8 September 2017

Re: Mayfield West Recycling Facility (SSD 7698) - Water Assessment

Potentially contaminating wastes area - water management

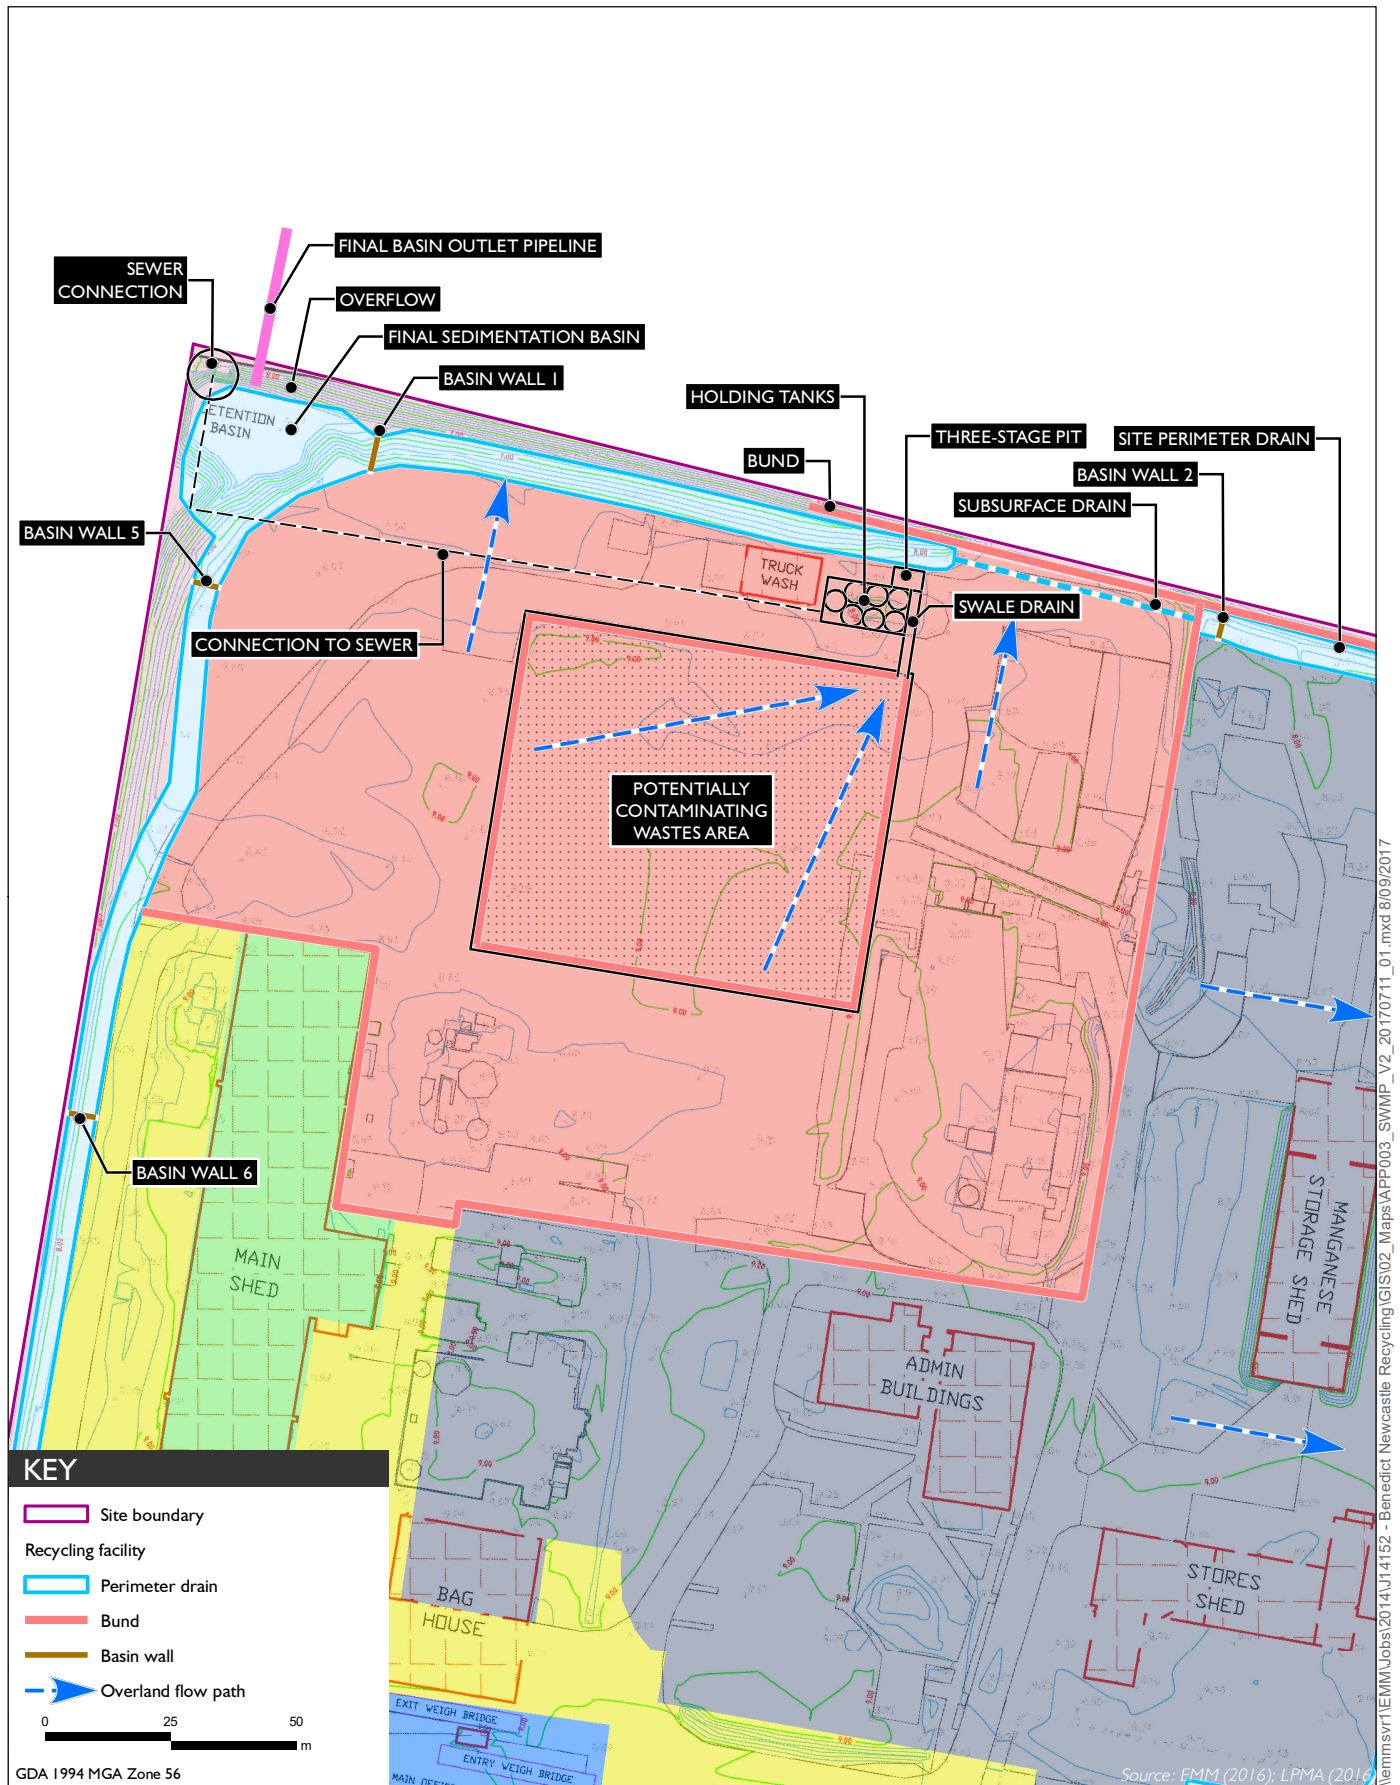
It is understood that the EPA remain concerned that the proposed management measures do not sufficiently reduce the risk from site discharge to the receiving environment, particularly from rain or dust suppression water that has contacted wastes stored externally in the segregated heavy waste processing and stockpiling area.

The following potentially contaminating wastes (based on the wastes listed in Condition L3.1 of EPL 20771) will be stored within a fully sealed and bunded designated potentially contaminating wastes area (see Figure 2.1):

The potentially contaminating wastes area (5,200 m²) will be sealed and bunded and be wholly within the wider segregated heavy waste processing and stockpiling area. It will be surrounded by a bund at least 100 mm high. The base of the potentially contaminating wastes area will be sealed with concrete or asphalt. A swale drain will carry water from this area to the three-stage pit.
